SUBJECT: Redline Pages to the Periodic Report 5 for the Upper Three Runs Integrator Operable Unit (IOU) (U) (SRNS-RP-2017-00548, Revision 1, July 2018) and Savannah River Site's Responses to Regulatory Comments on the Revision 0 Document, CERCLIS Number: 70

**Final SRS Responses to EPA Comments on
Periodic Report 5 for the Upper Three Runs IOU,
SRNS-RP-2017-00548, Revision 0, February 2018, CERCLIS Number: 70
Page 1 of 9**

Final SRS Responses to South Carolina
Department of Health and Environmental Control Comments on:
Periodic Report 5 for the Upper Three Runs Integrator Operable Unit (IOU) (U),
CERCLIS Number: 70 (SRNS-RP-2017-00548, Revision 0, February 2018)
Page 1 of 3

Figure 1-56. Upper Three Runs IOU Conceptual Site Model

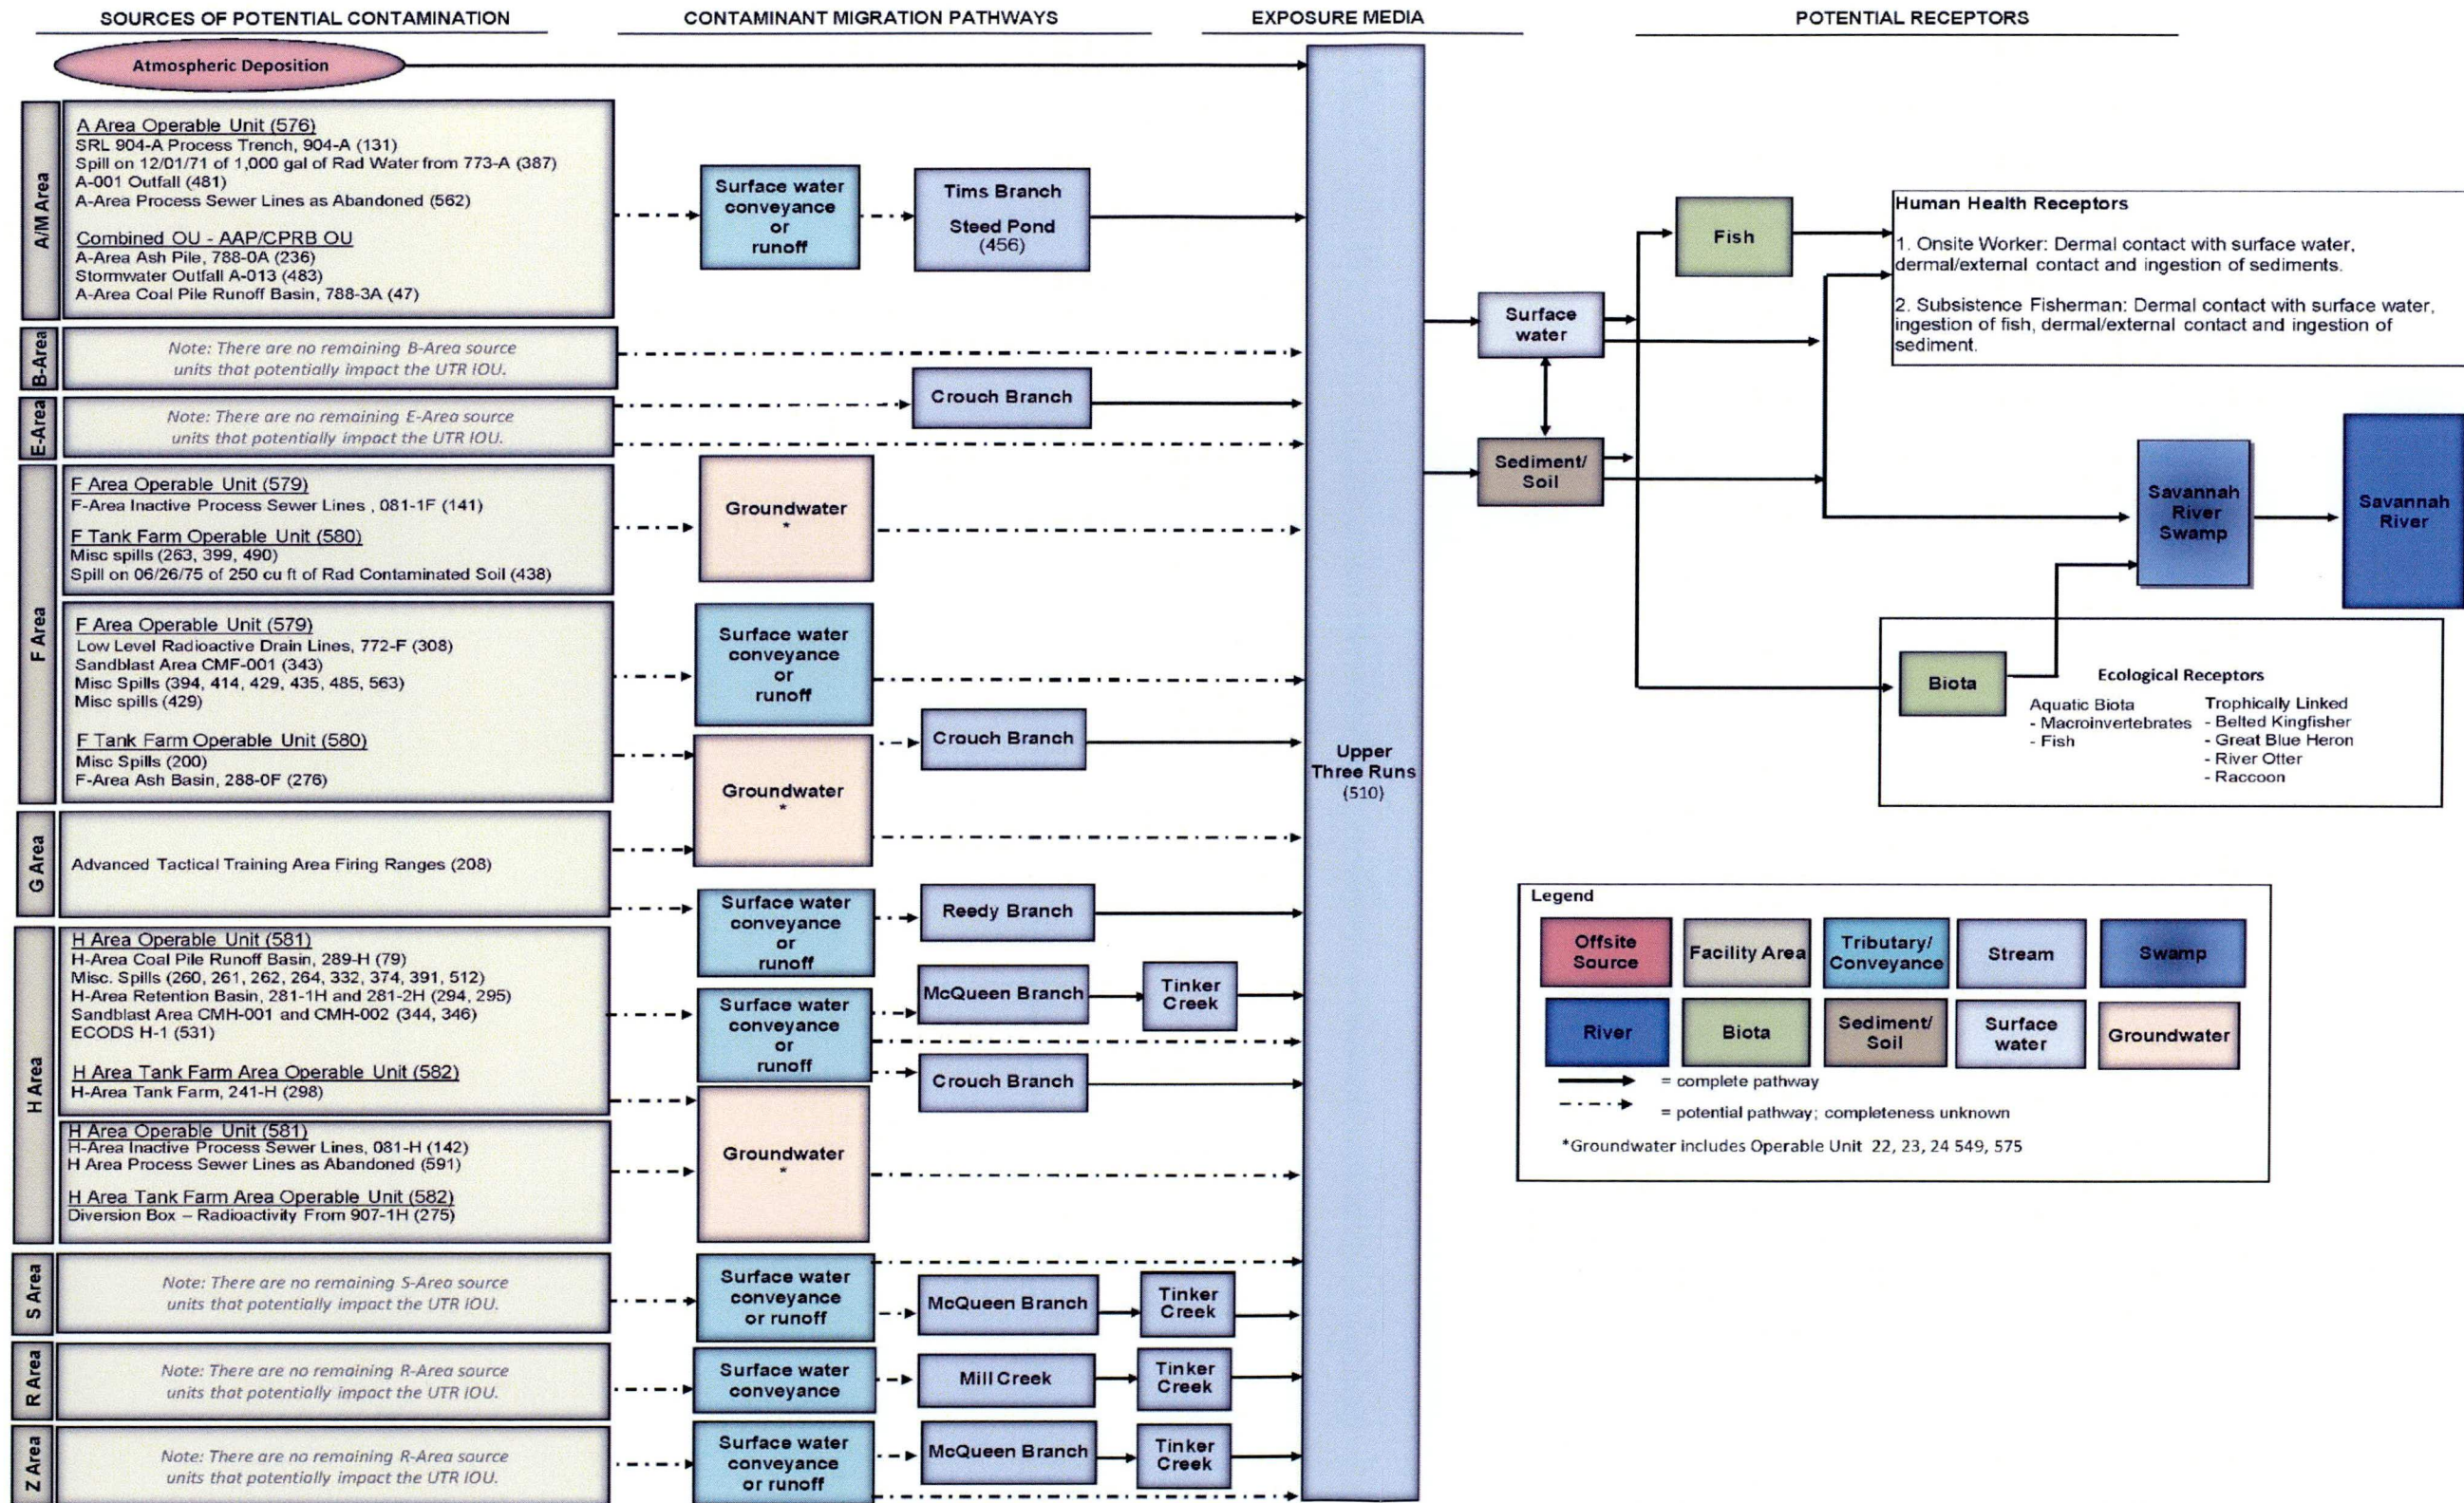
1. Figure 1-4a through Figure 1-4f, pages 1-23 through 1-33. Figures 1-4a through 1-4f should be labeled “Operable Units, Potentiometric Contours, and Groundwater Plumes Associated with the UTR IOU” for each unit area as stated on pages 1-23 through 1-33. Also, in the revision of PR5, please delete the additional copy of Figure 1-4c and insert Figure 1-4d.

Response: Agree. The new Figures 1-4a to 1-4d represent “Operable Units and Topography Associated with the UTR IOU”, and the new Figures 1-5a to 1-5d are “Operable Units, Potentiometric Contours and Groundwater Plumes Associated with the UTR IOU” and labeled appropriately.

Figure 1-5c: Operable Units, Potentiometric Contours, and Groundwater Plumes Associated with the UTR IOU - H, S and Z Areas

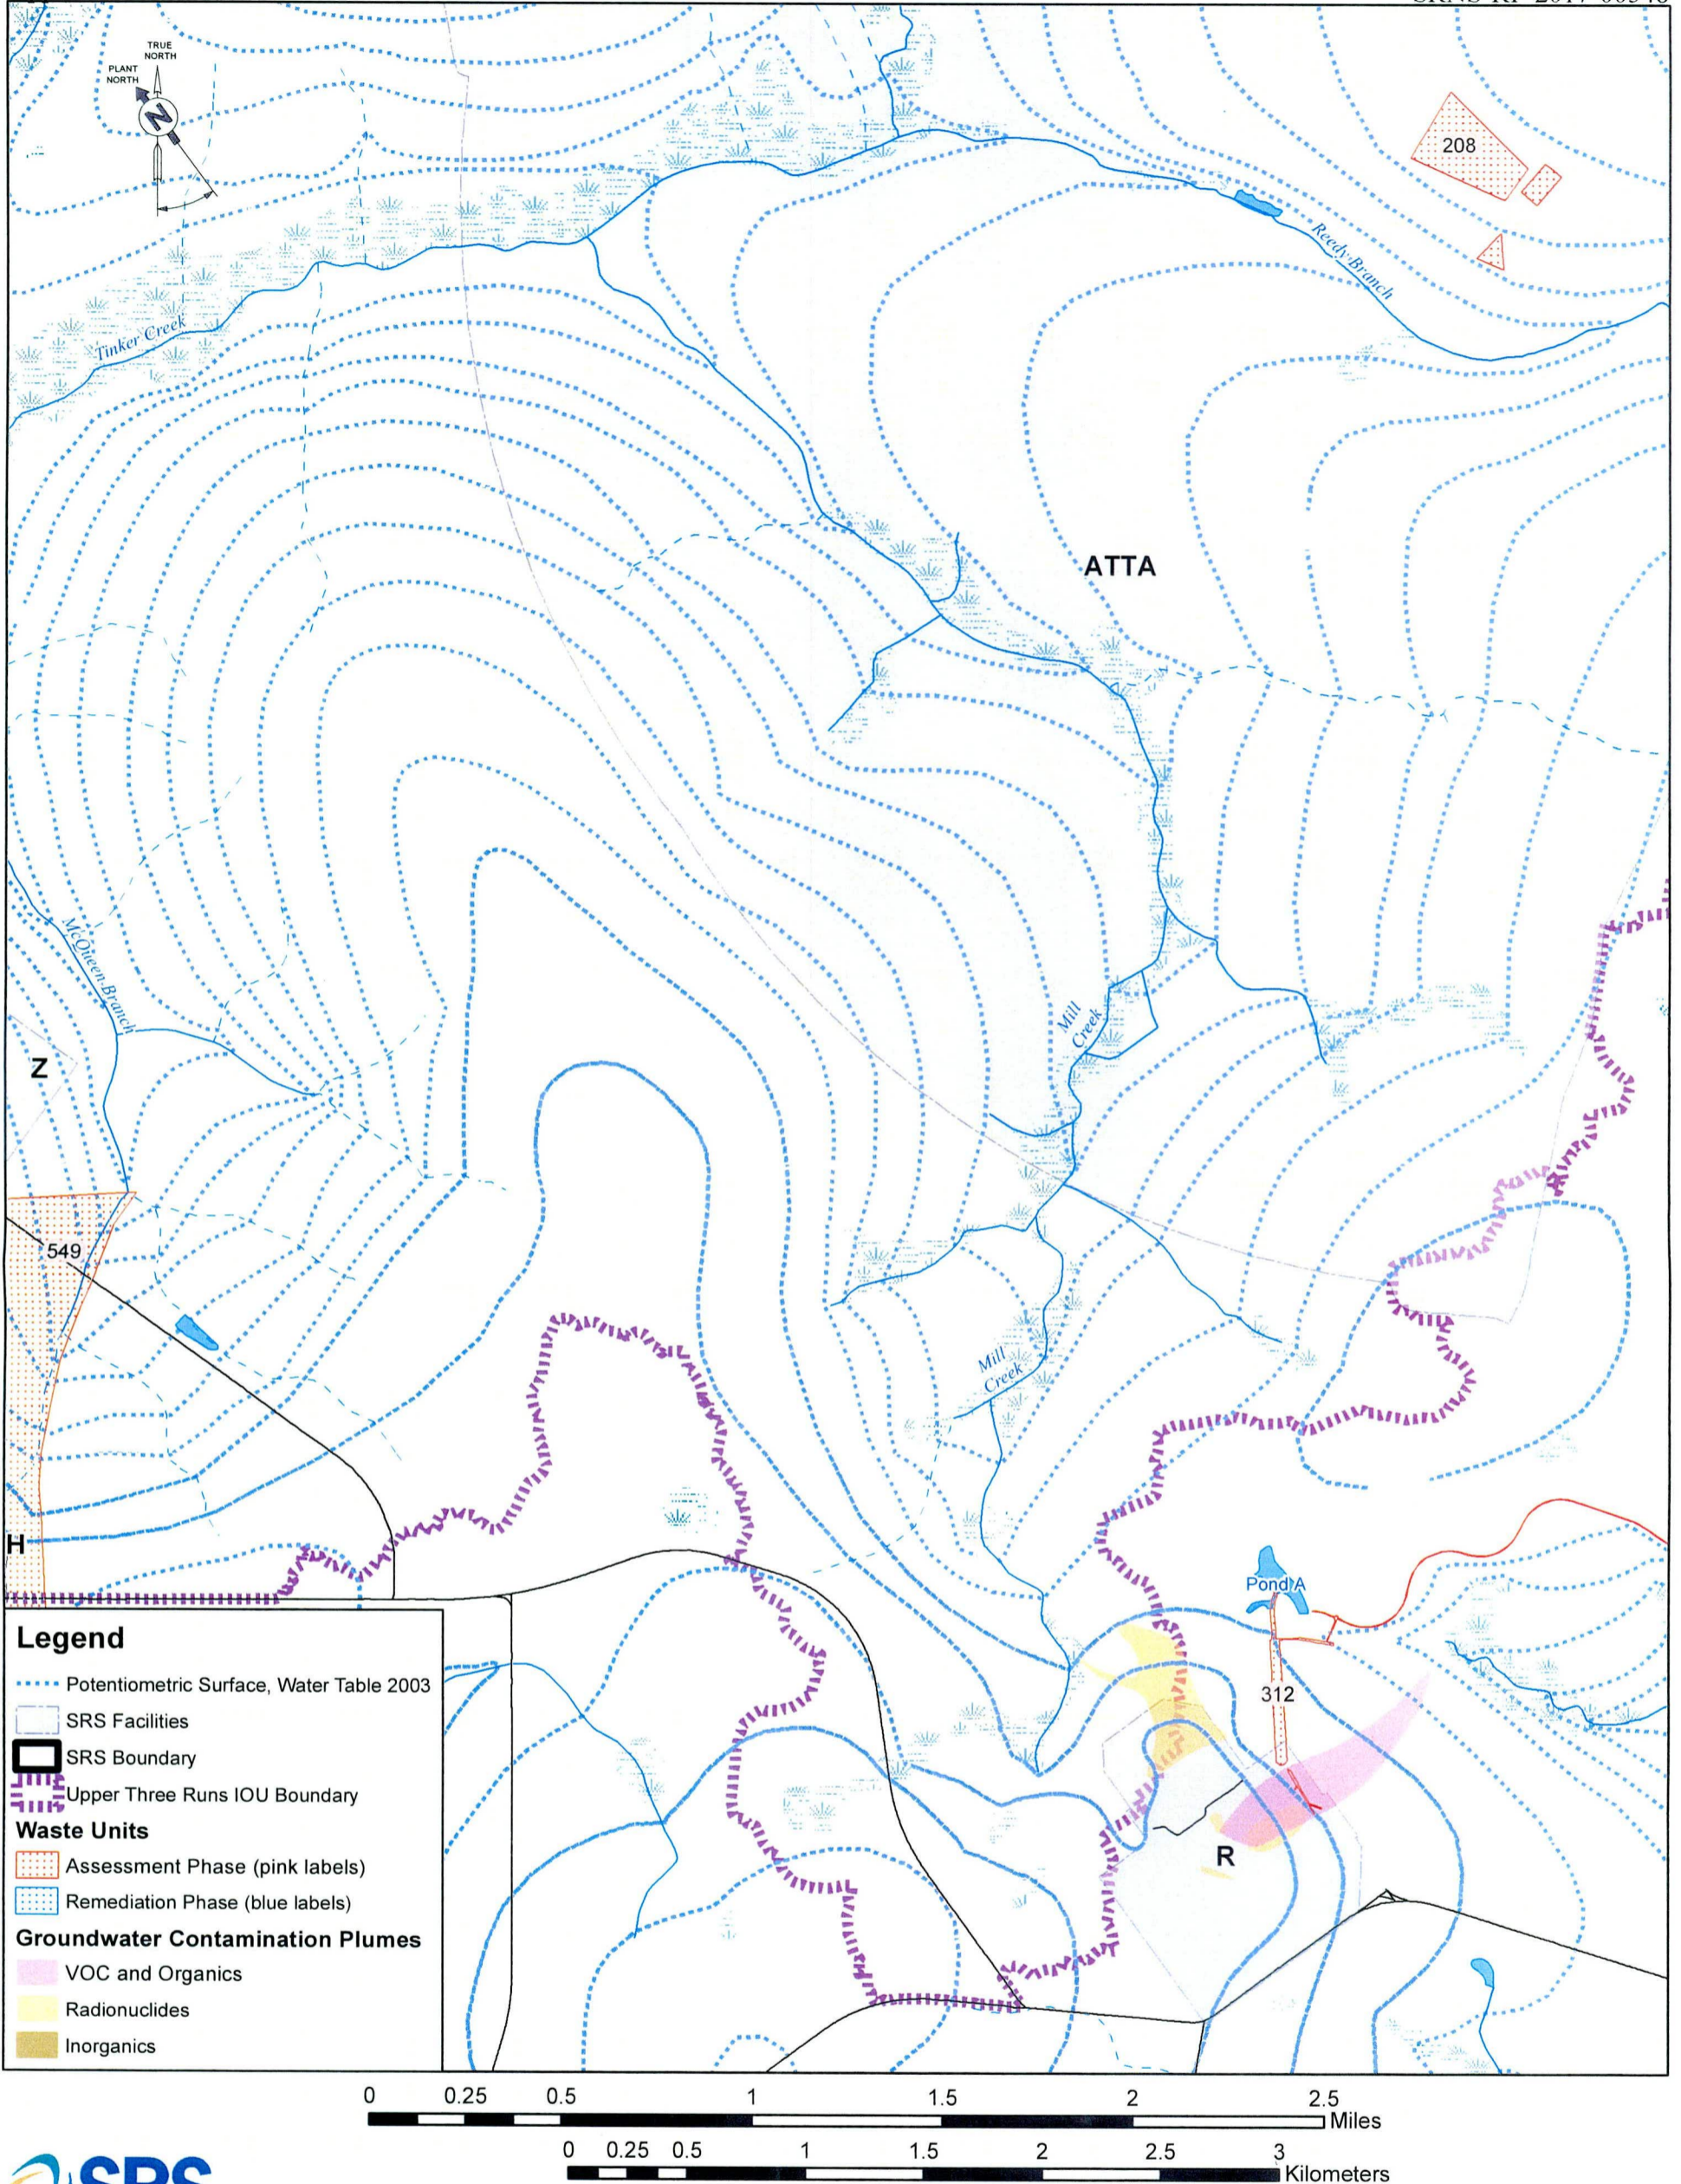
2. Figure 1-4d, Operable Units, Potentiometric Contours, and Groundwater Plumes Associated with the UTR IOU – H, S, and Z Areas, page 1-31 of 1-58:

Figure 1-4c Operable Units, Potentiometric Contours, and Groundwater Plumes Associated with the UTR IOU – F and E Areas is duplicated and is included in place of Figure 1-4d, Operable Units, Potentiometric Contours, and Groundwater Plumes Associated with the UTR IOU – H, S, and Z Areas in the UTR PR5 Report. *Please revise the UTR PR5 Report to include the missing Figure 1-4d for the H, S, and Z areas.*

Response: Agree. The figure (now Figure 1-5c) will be included in the revised document.
